RE: Raymond Winery UP-Water/WWFS and UP

Project Number 2010080

The following is in response to the letter prepared by Abbot & Kindermann, LLP in regards to the proposed Raymond Vineyard and Cellar Use Permit Modification (P11-00156); specifically addressing the engineering comments related to stormwater, process wastewater treatment and proximity to groundwater, and the water availability/demand analysis.

# **Hydrograph Report**

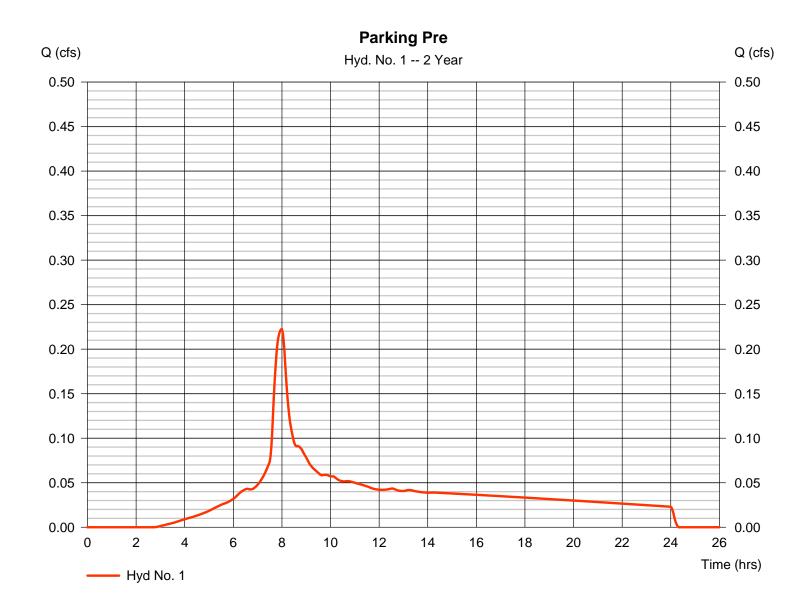
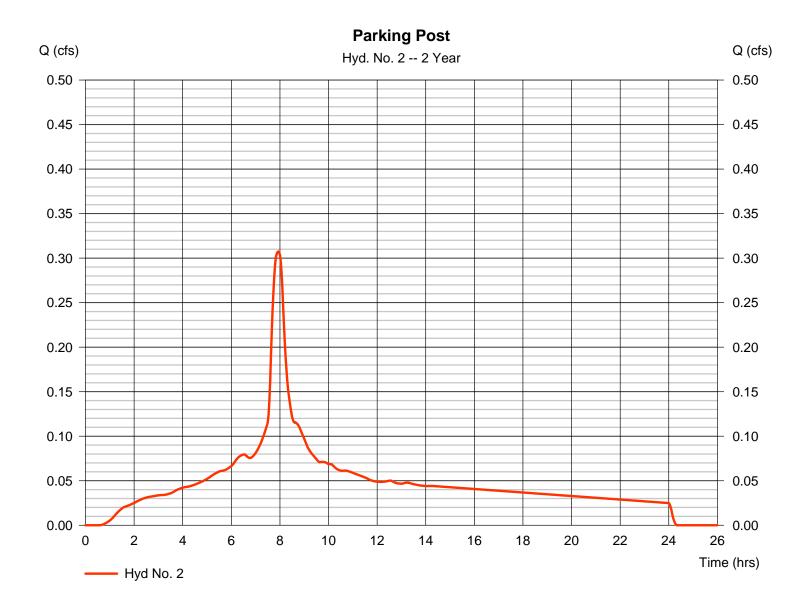
The saturated hydraulic conductivity, Ksat, was taken from the NRCS website to use as a conservative infiltration rate for calculating the amount of time it would take to infiltrate the added runoff. We understand that this approach is consistent with County requirements. The swale depth is proposed to be 1 foot; therefore, an average Ksat value (5.59 micrometers per second) for a depth of soil between 0 to 24 inches was used. Given this infiltration rate and the available area for bioswales, all of the added runoff from the 2-year, 24 hour rainfall event would infiltrate within 16.6 hours, which is below the Napa County vector control requirements of 48 hours. The size and geometry of the swales may be revised during the design phase of the project in order to adjust the time to infiltrate. Any runoff not infiltrated into the biowales (from larger storm events) would overflow onto the adjacent vineyards and

. 0
1,264
170
0.000018
1152
59823.13
16.62

Post-Project Runoff - Pre-Project Runoff (4,429 - 3,165 = 1,264 ft3)

SITE PLAN 1991 UYINGRY WASTEWATER FOHD#2 RAYIMONDVINIETARD \$ CELLAR, THE

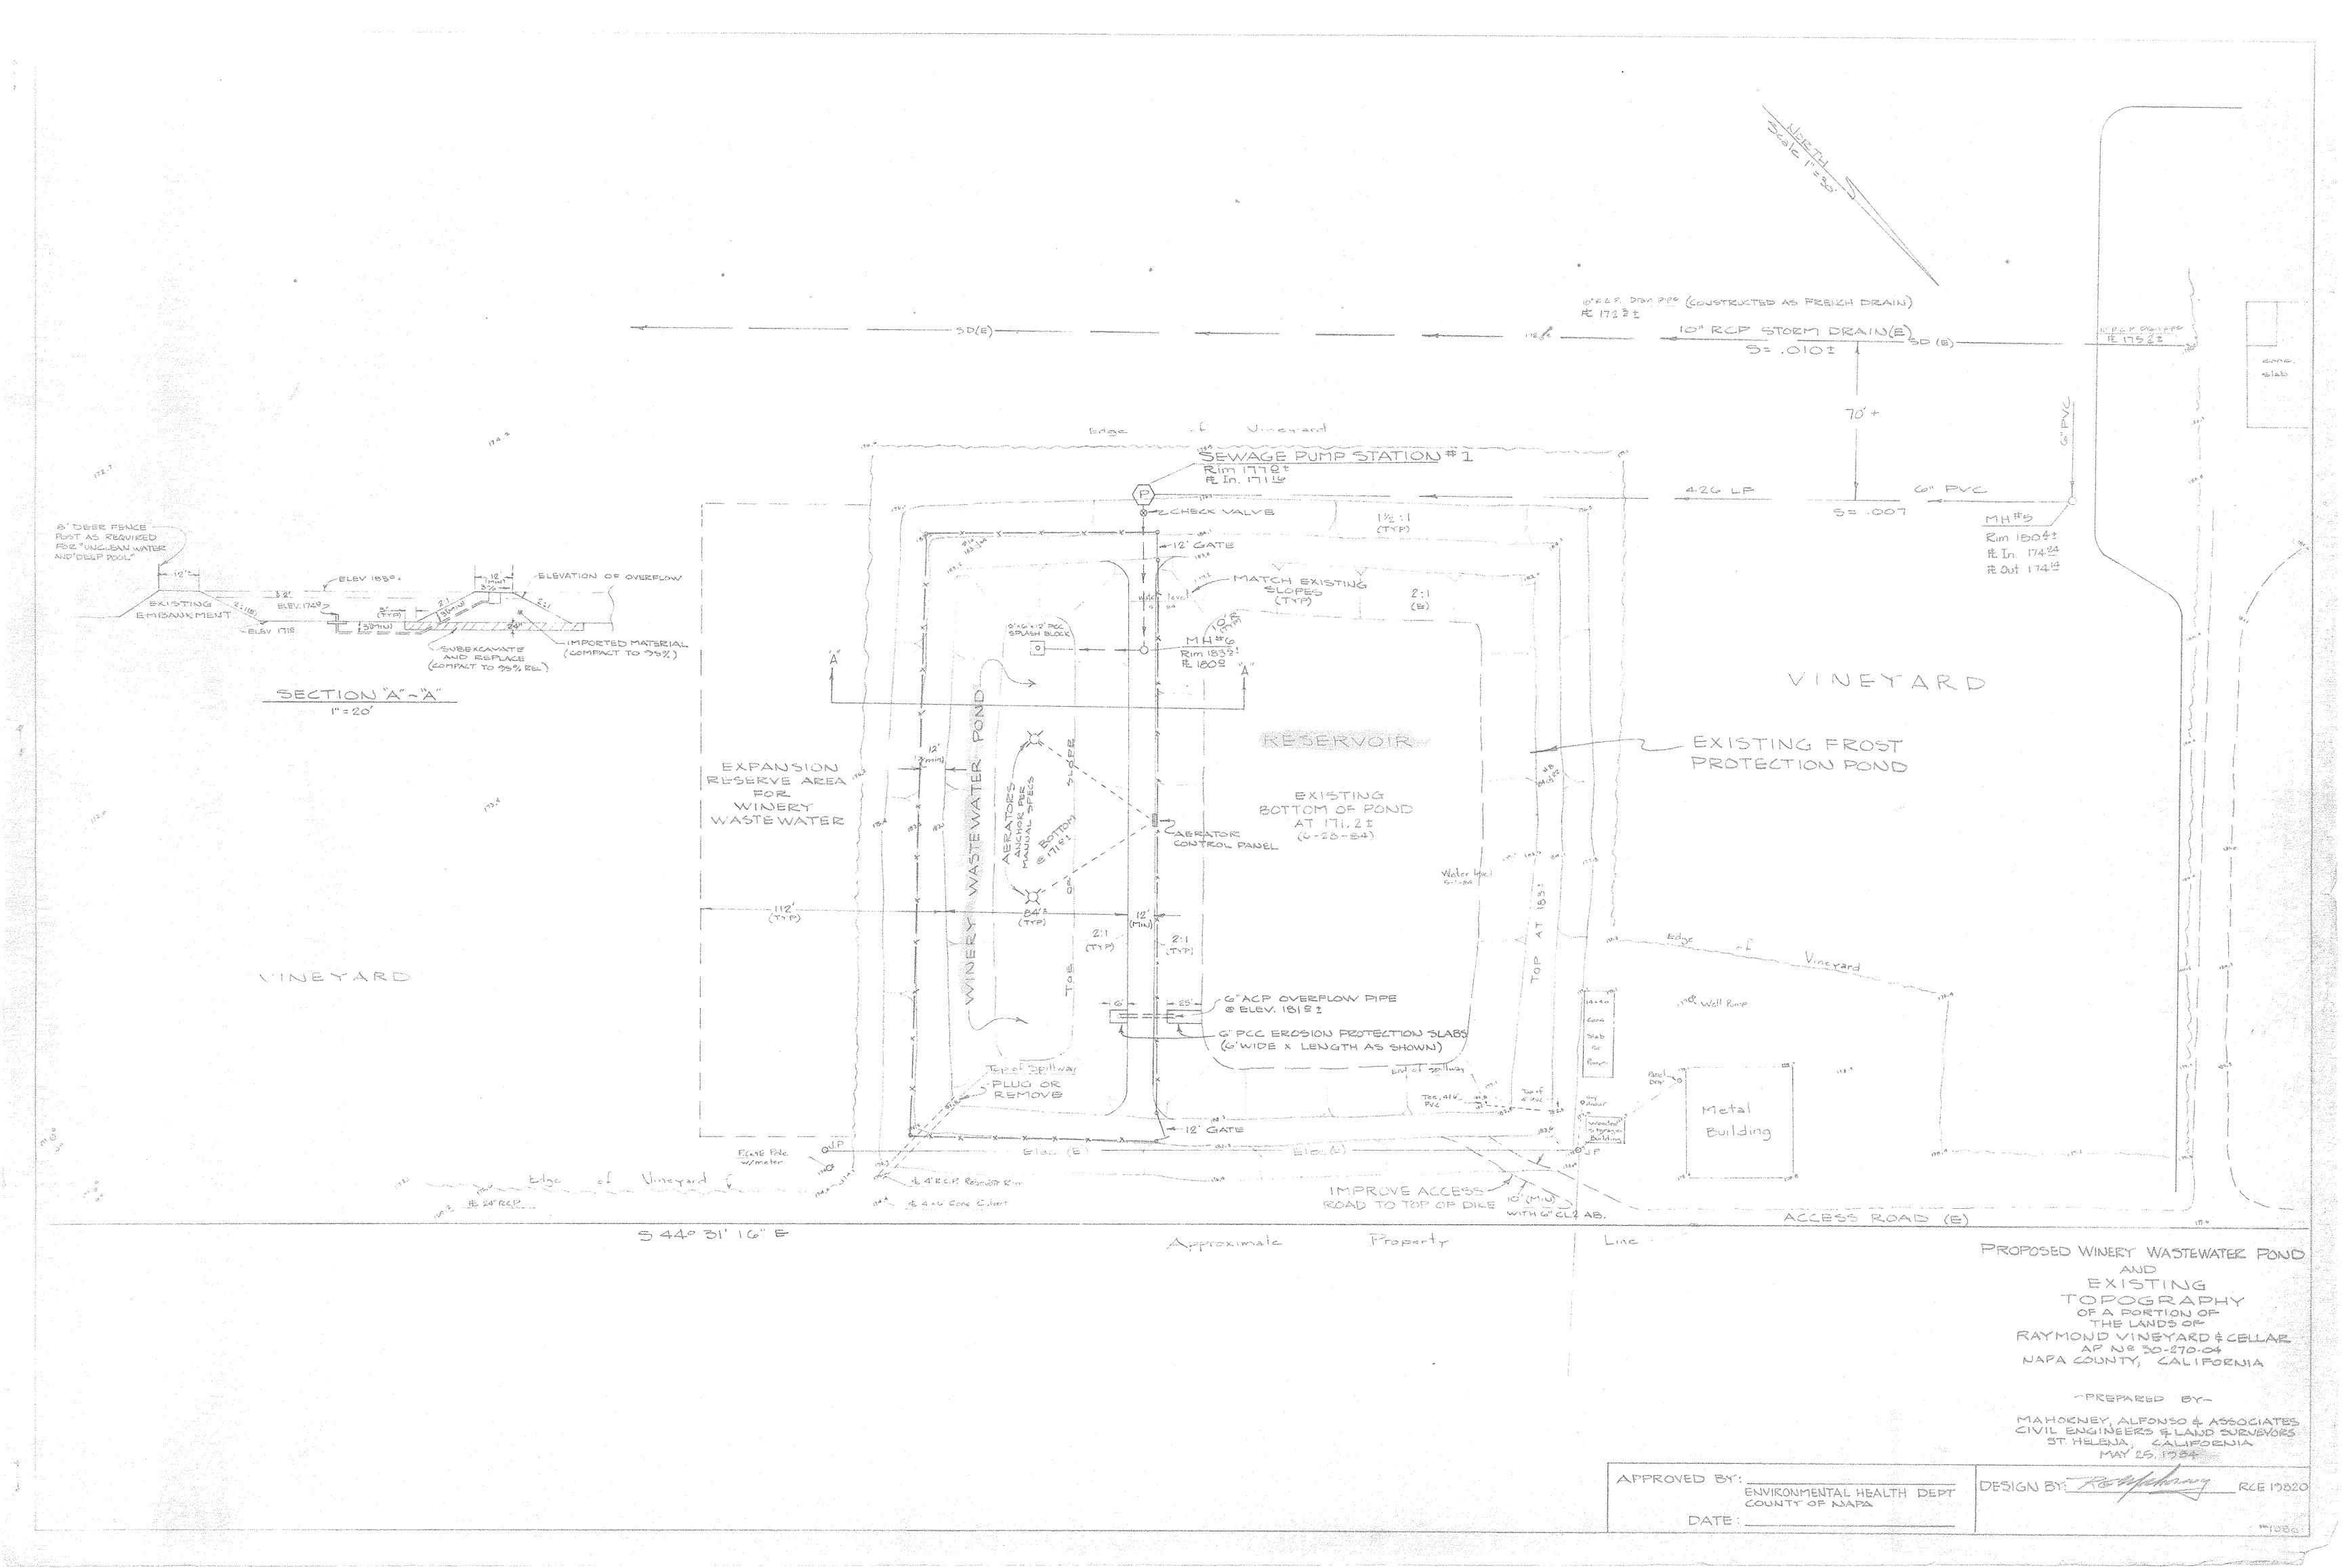
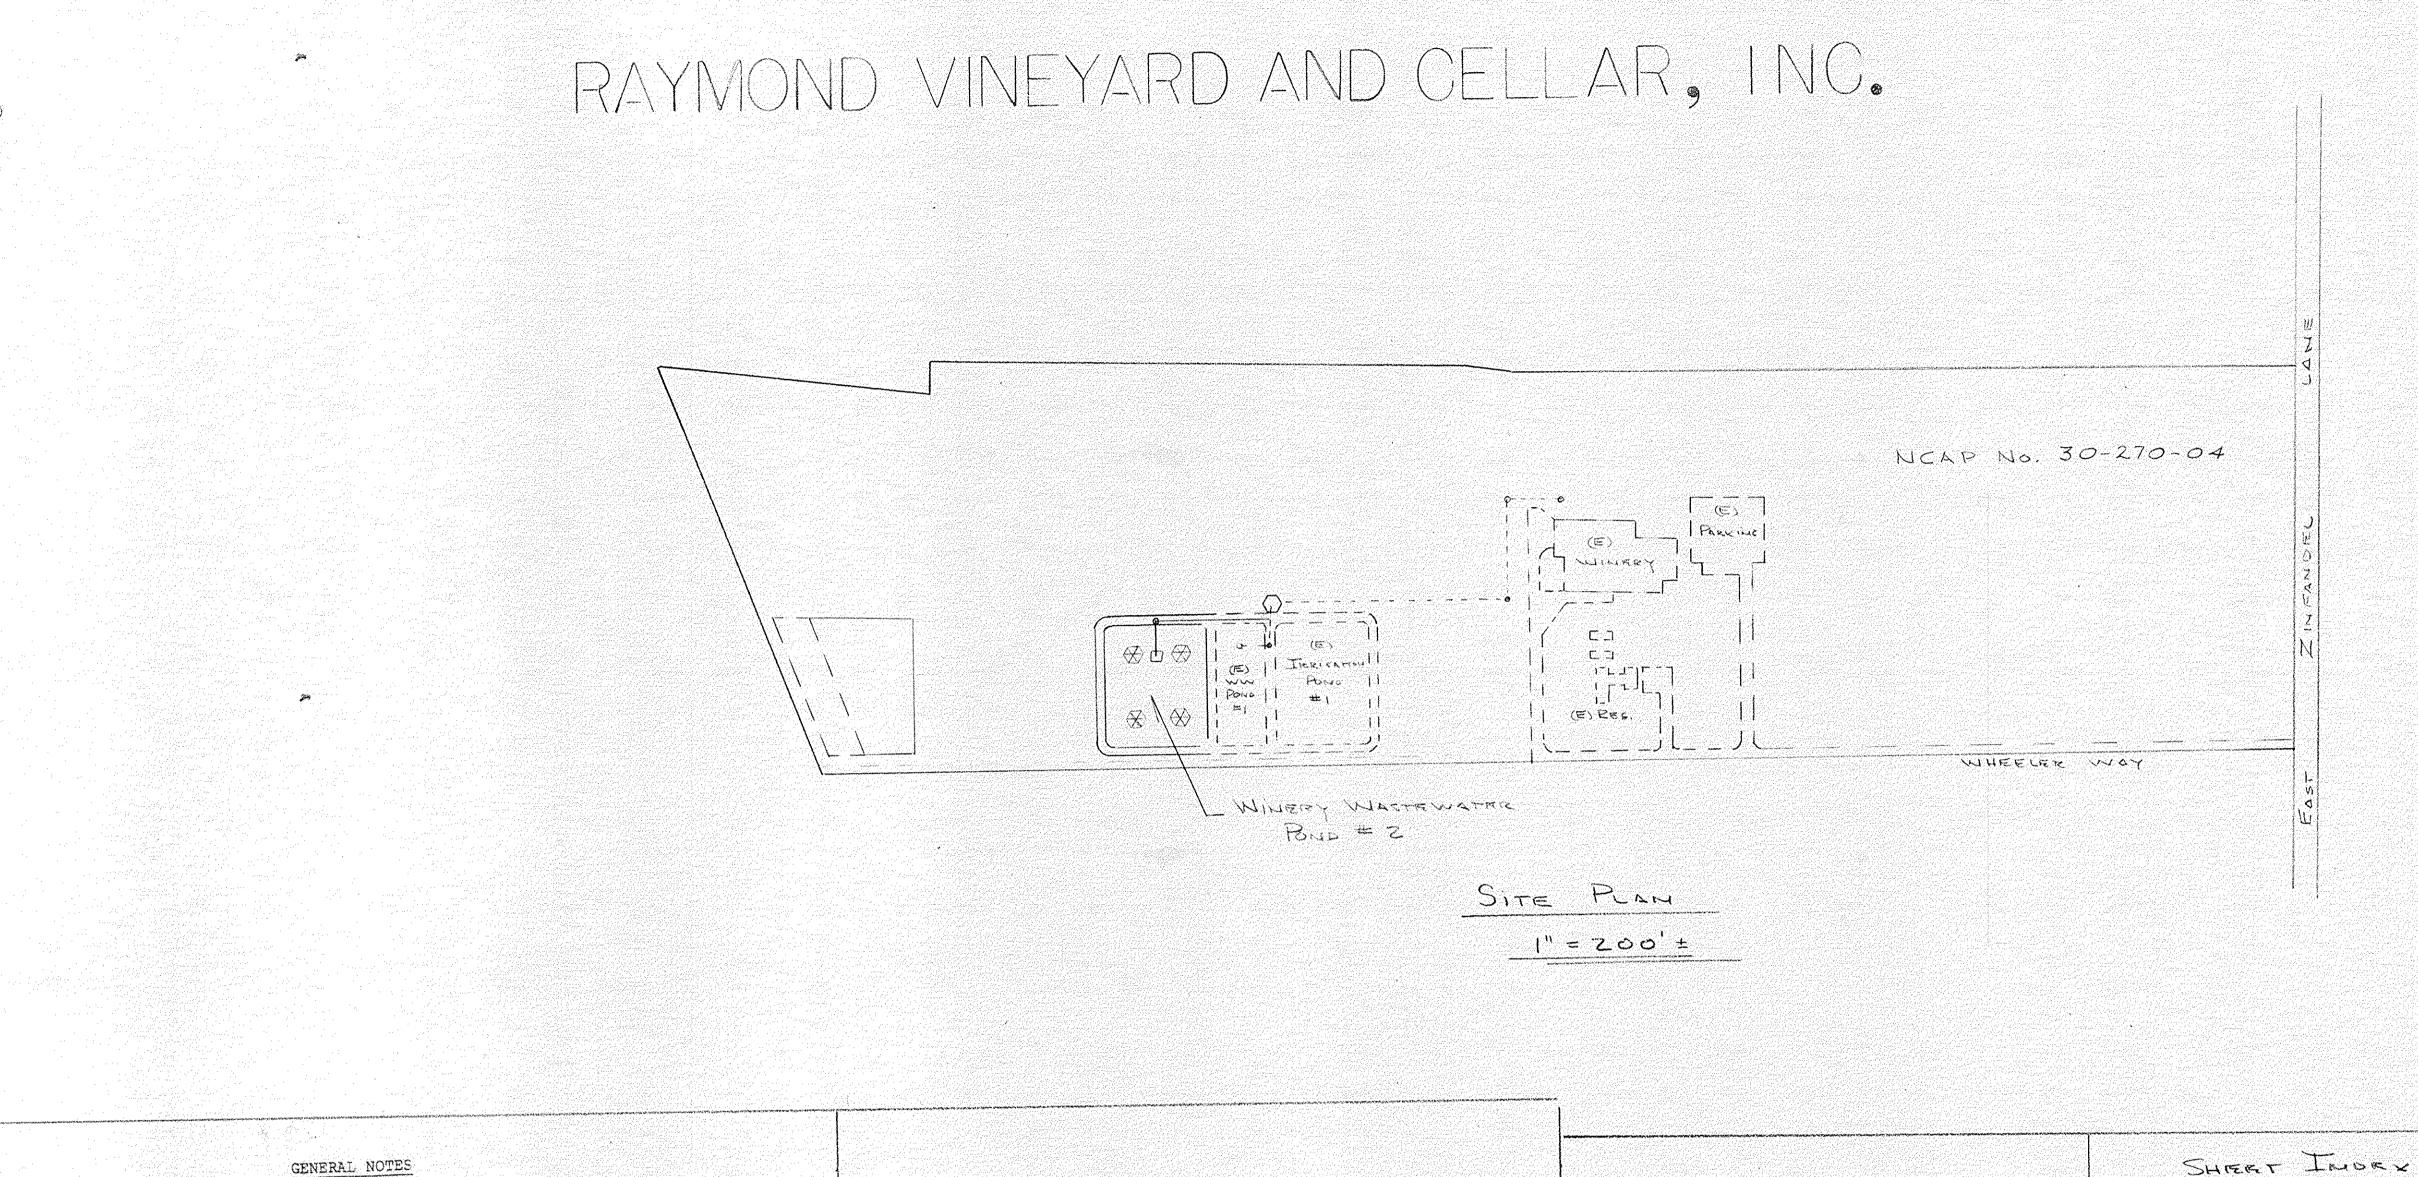
Per the original wastewater pond drawings (attached), the ponds were constructed above existing grade. The pond bottom elevations range from approximately 171-173 with the top of berm elevation ranging from approximately 183-184. Surrounding ground elevations, outside of the pond limits, range from approximately 172 (south end) to 177 (north end). Therefore, the ponds extend partially into grade by about 1-6 feet. Additionally, each of the ponds were originally constructed with a 3-foot minimum clay liner (with permeability of less than  $10^{-6}$  cm/sec maximum per the County/State standards) to provide protection to groundwater.

The integrity of the existing clay liner could be confirmed by Geotechnical Engineering as part of the permit conditions to ensure that adequate groundwater protection is being maintained.
